**PROCUREMENT OF EQUIPMENT FOR CLINIC FOR INFECTIOUS AND
TROPICAL DISEASES OF THE CLINICAL CENTER OF SERBIA
(PROCUREMENT NO. IOP/65-2022/UHI)**

CLARIFICATION NO. 3

Issued on June 22, 2022

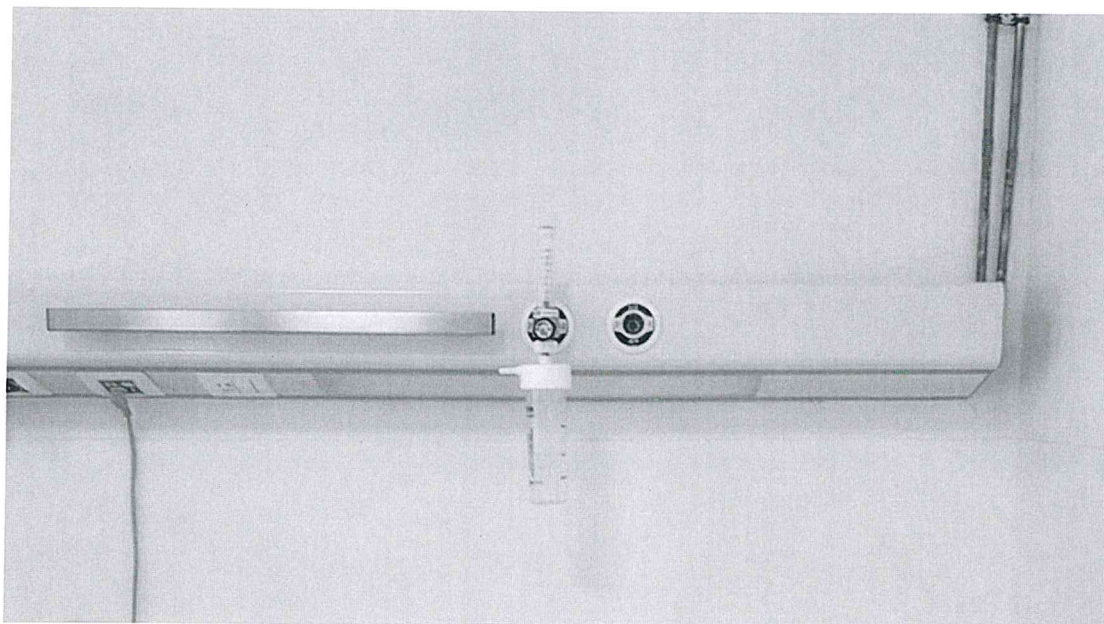
With regard to item n. 19 "Oxygen flowmeter" please clarify:

- the type of terminal unit into which the flowmeter is to attach;
- the clearance required for the medical rail

Terminal unit id DIN Dreager, and the medical rail is just beside, as you can see on photo
